Date: May 7, 2026
To: All Prospective Bidders
From: Candida Poinsette
Assoc. Director of Procurement Services
Re: Addendum Number 2
IFB # C1747 – Façade Repairs – Kaufman Hall

Re: Façade Repairs
Kaufman Hall
Fashion Institute of Technology
406 West 31st Street
New York NY 10001

Questions IFB # C1747 – Kaufman Façade Repairs

2 SPANDREL BEAM REINFORCEMENT DETAIL
A-205 SCALE: 3"=1'-0"

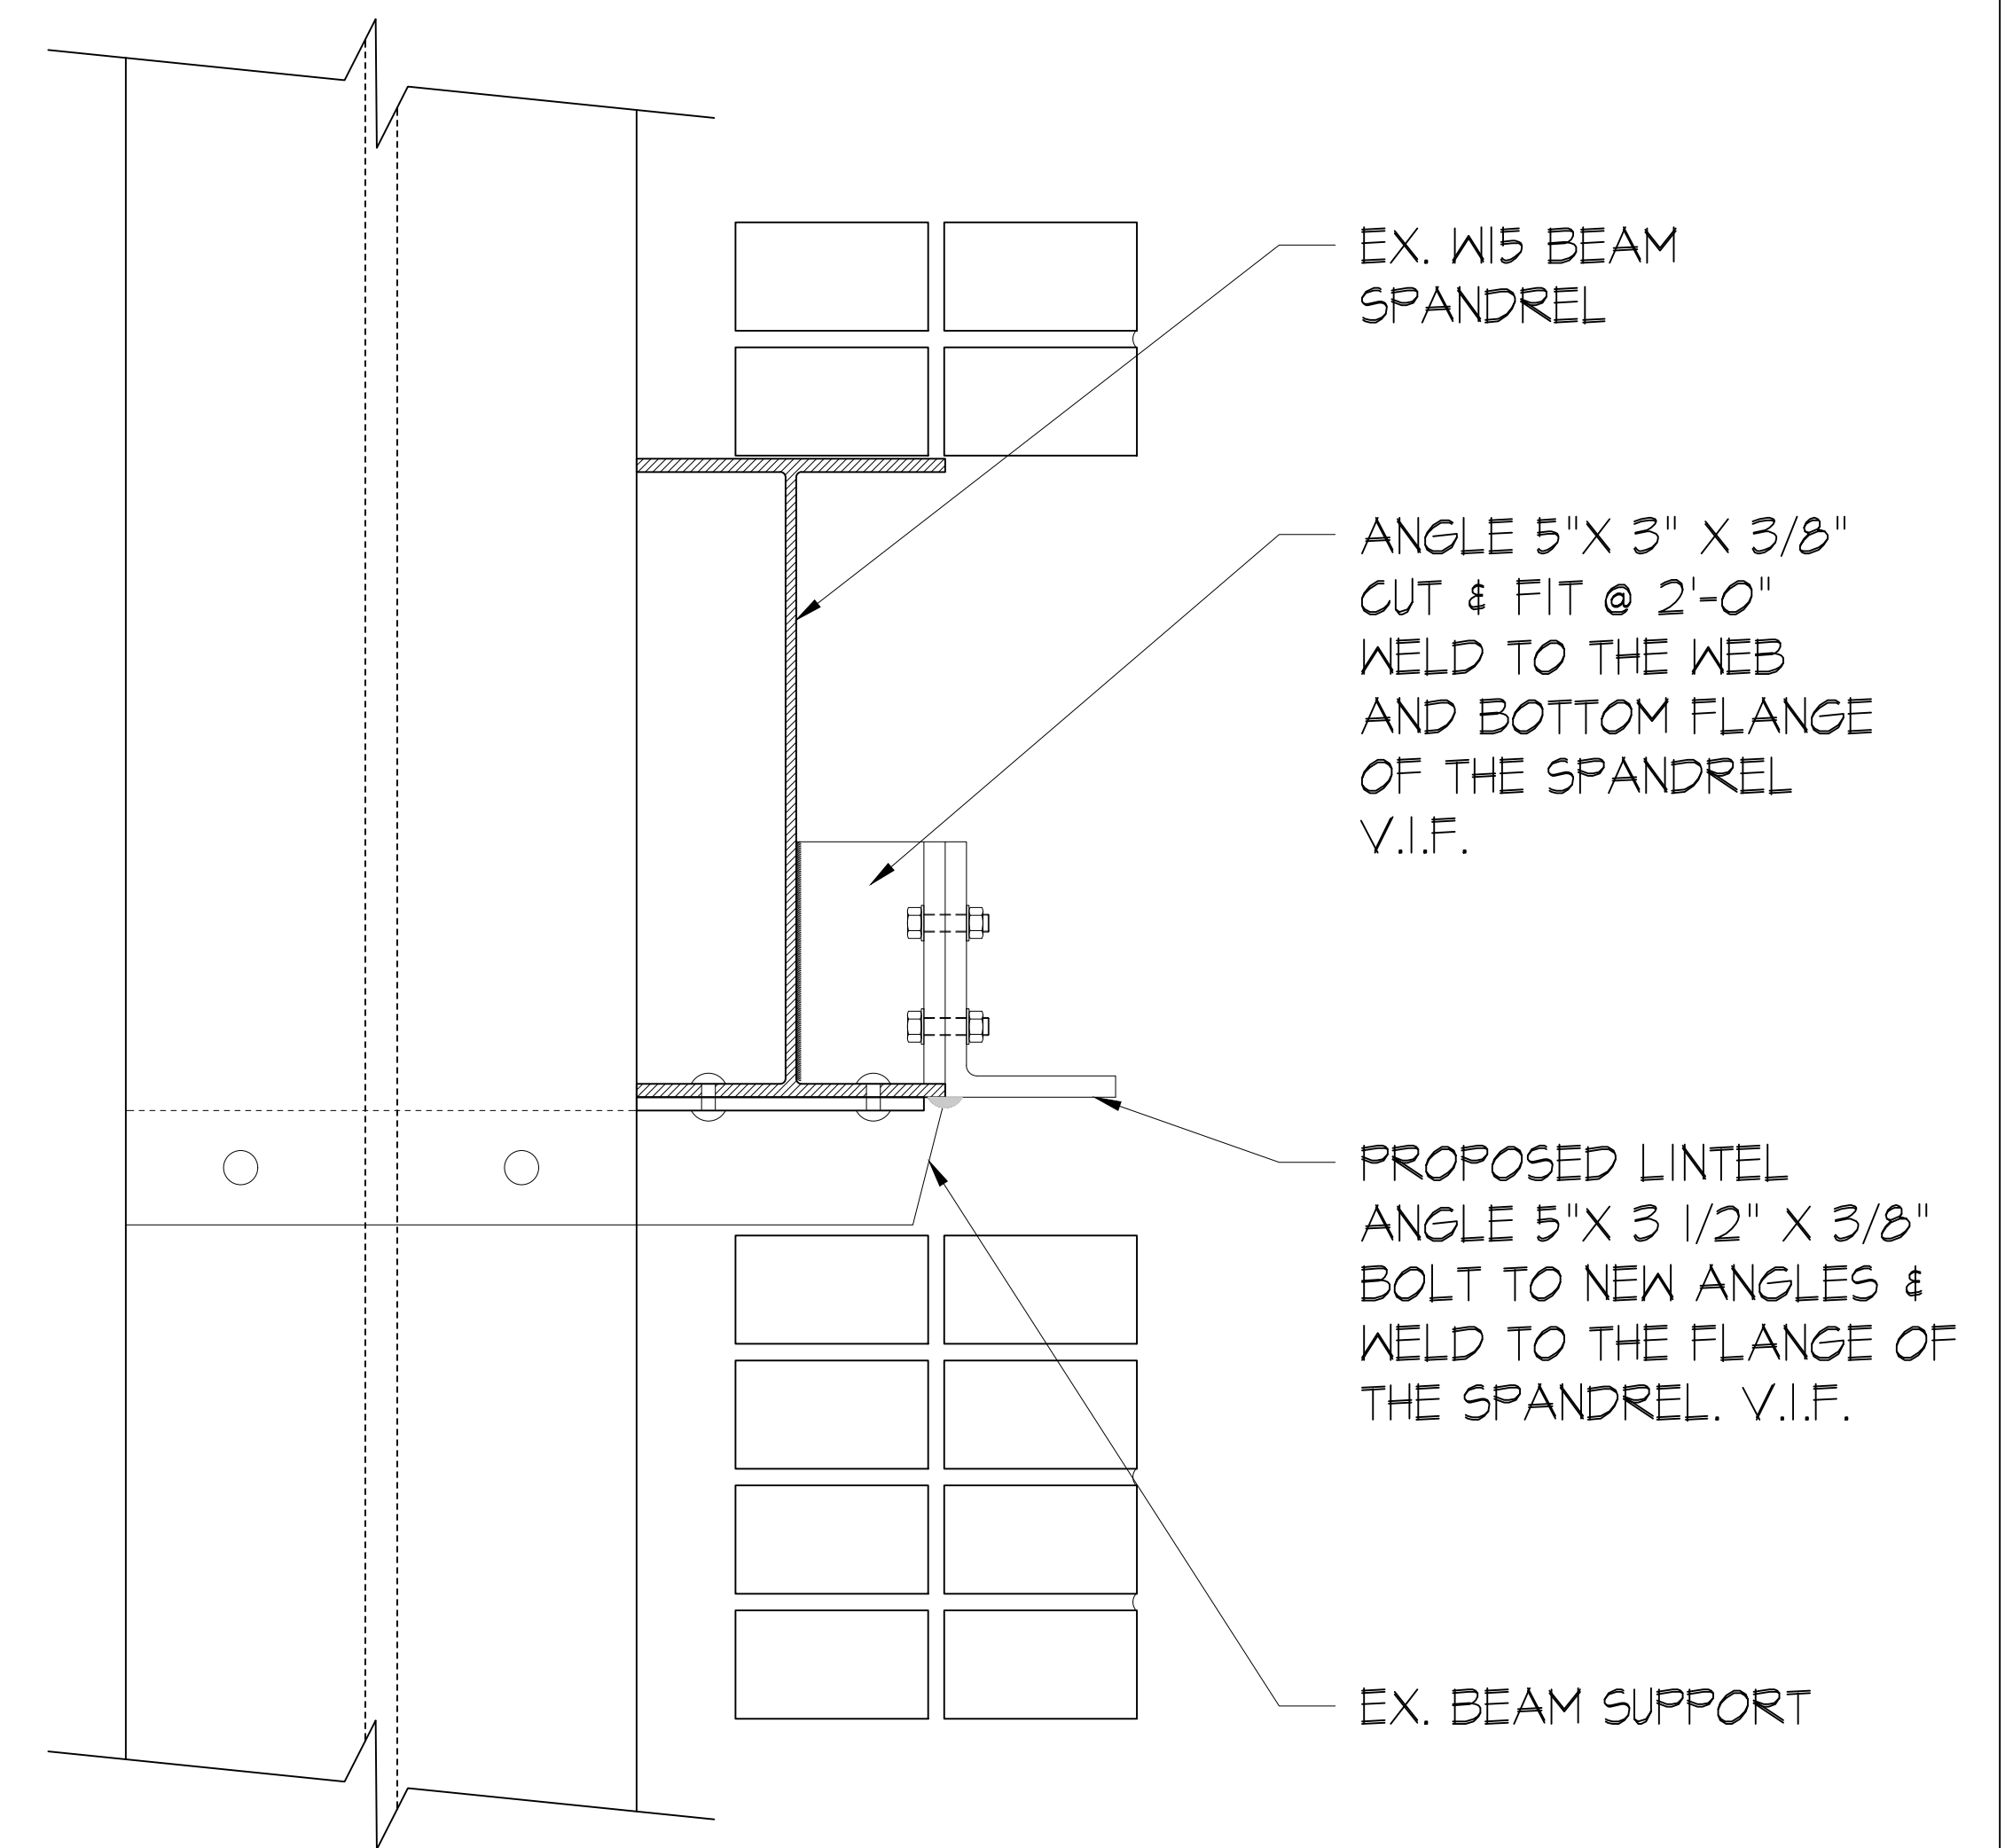
RFI #26. Section 6B – Shelf Angle Repair (Type B): Is there a detail available for this repair? How many bricks in the back-up are we replacing. Is this including only SPP of the angle? Please confirm the type of reinforcement required.

RFI #26 Response. See revised drawing, Detail 2/A-205

1 PROPOSED LINTEL REPLACEMENT DETAIL
A-206 SCALE: 3"=1'-0"

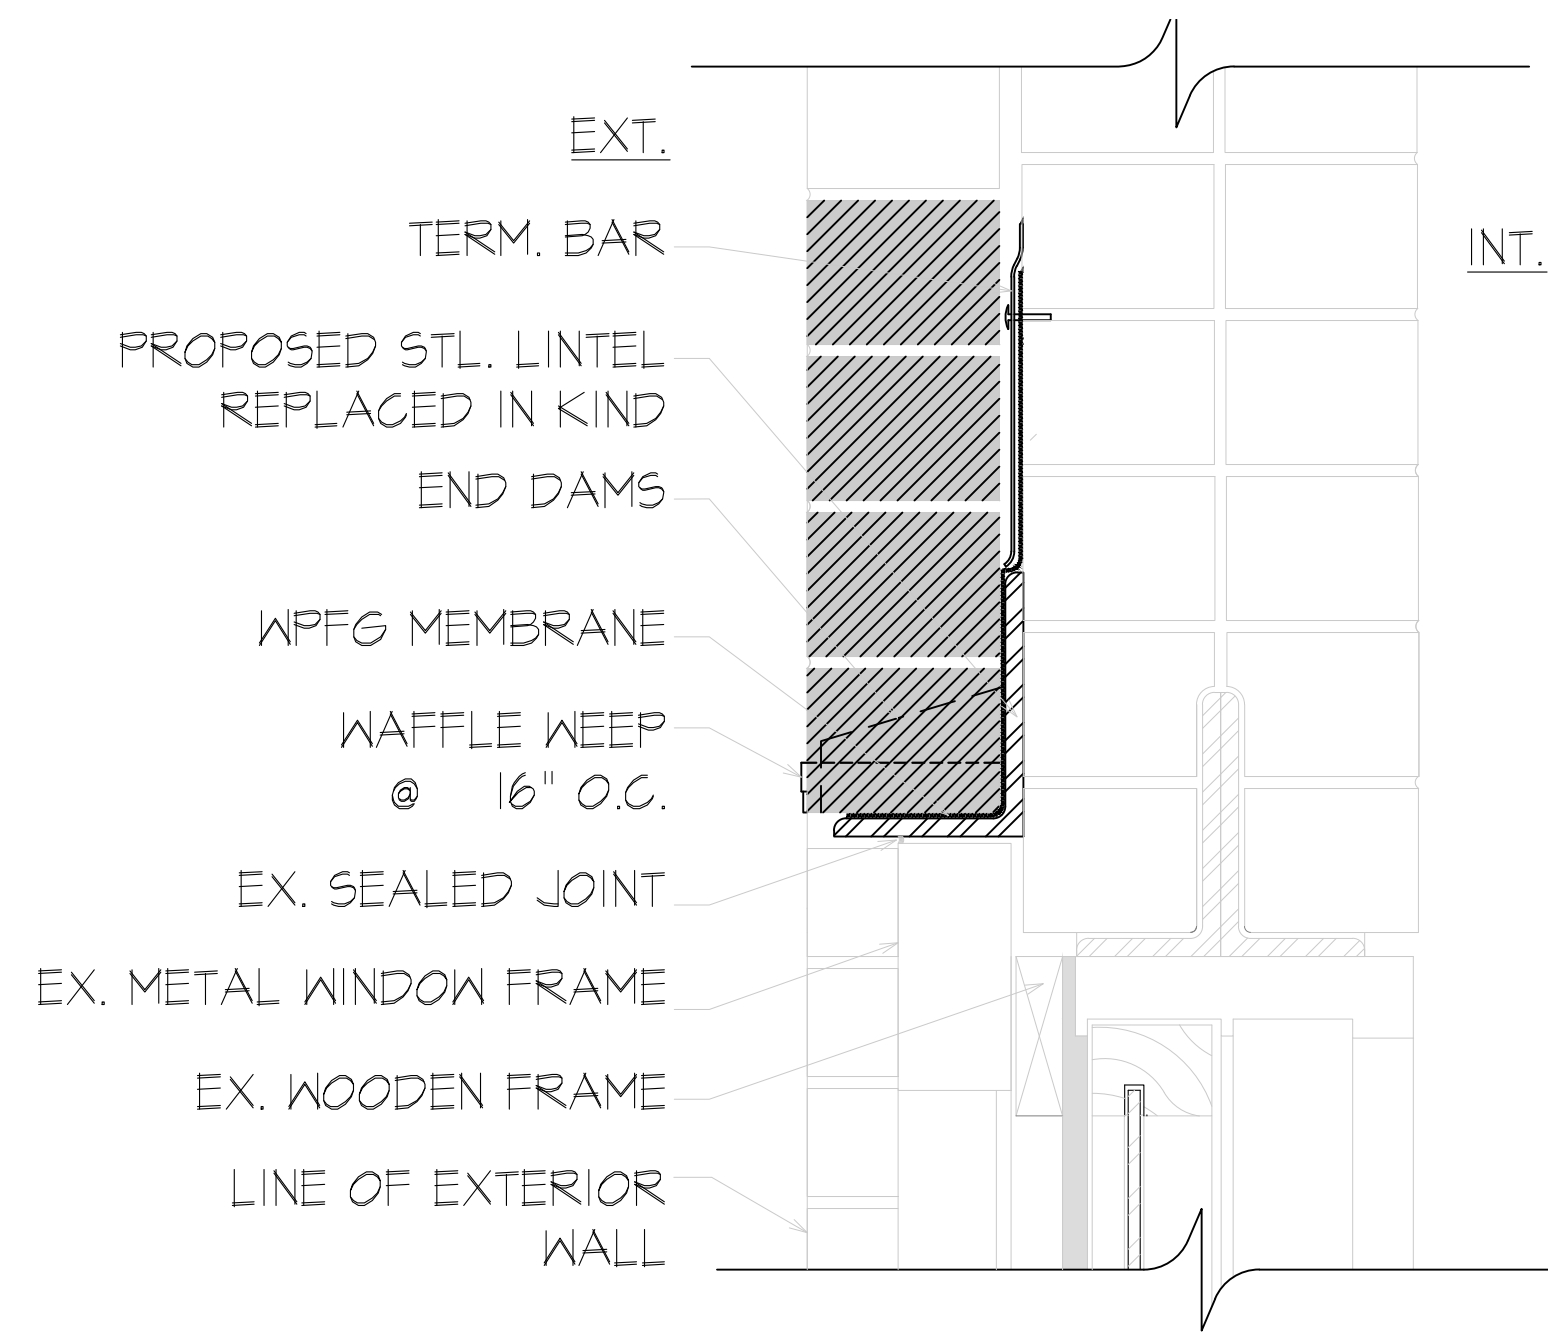
RFI #19. Section 3.6A – Window Lintel Replacement: Is there a detail available for this repair? Please confirm whether the lintel is to be loose, bolted, or welded. Also, how many bricks are to be replaced above the lintel?

RFI #27. Section 7A – Window Lintel Replacement: Is there a detail available for this repair? Please confirm whether the lintel is to be loose, bolted, or welded. Also, how many bricks are to be replaced above the lintel? Provide the detail.

RFI #19 Response. See revised drawing, Detail 1/A-206

RFI #27 Response: See revised drawing, Detail 1/A-206

2 PROPOSED SILL REPLACEMENT DETAIL
A-206 SCALE: 3"=1'-0"

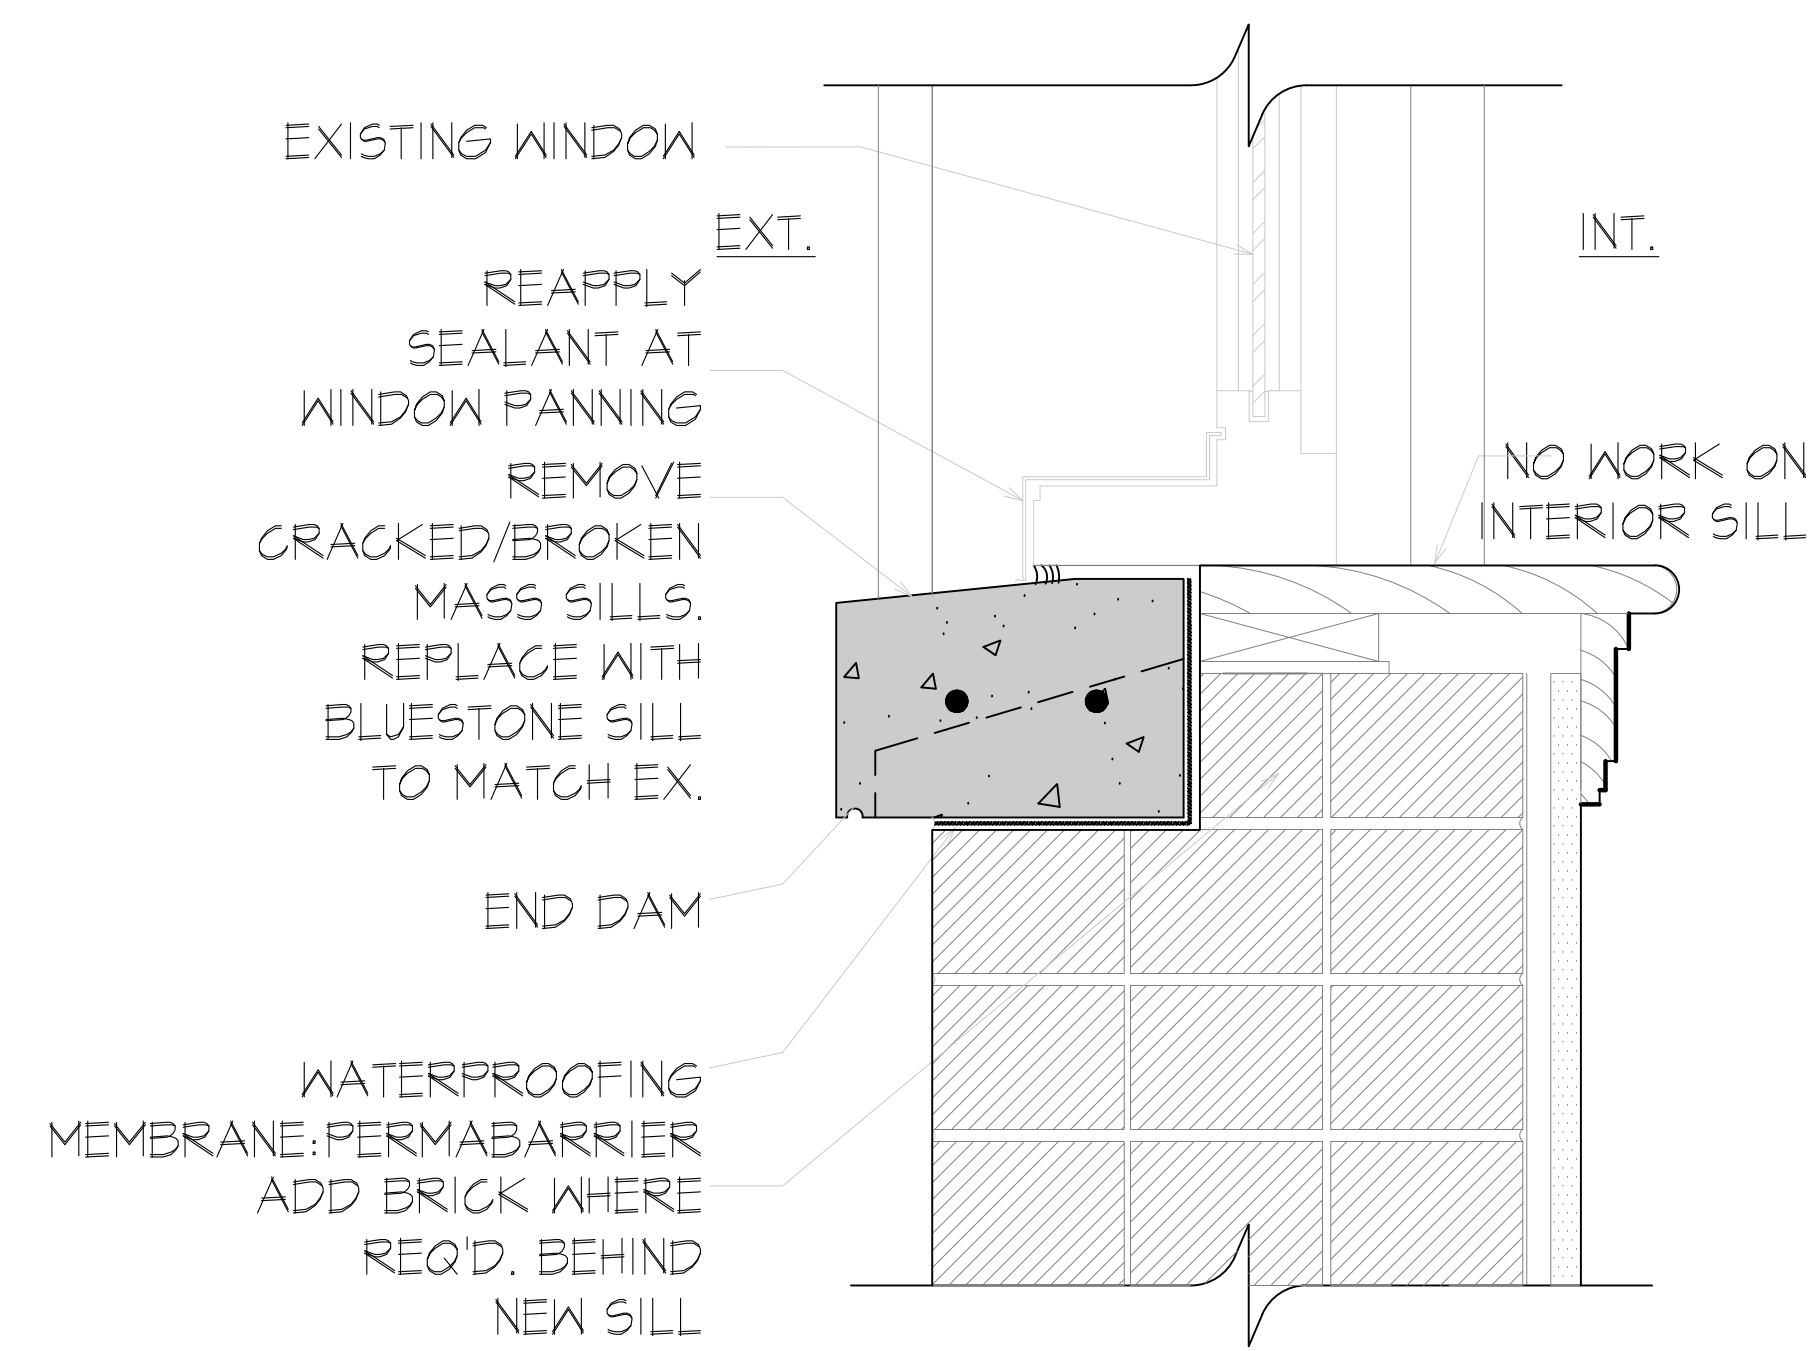
RFI #17. Section 3.4 – Window sill Replacement: Could you provide a detail for this repair? Should we assume replacement with a precast sill?

RFI #23. Section 3.4 – Windowsill Replacement: Could you provide a detail for this repair? Should we assume replacement with a precast sill?

RFI #17 Response. Replacement sill to be precast concrete. See revised drawing, Detail 2/A-206

RFI #23 Response. See RFI 17.
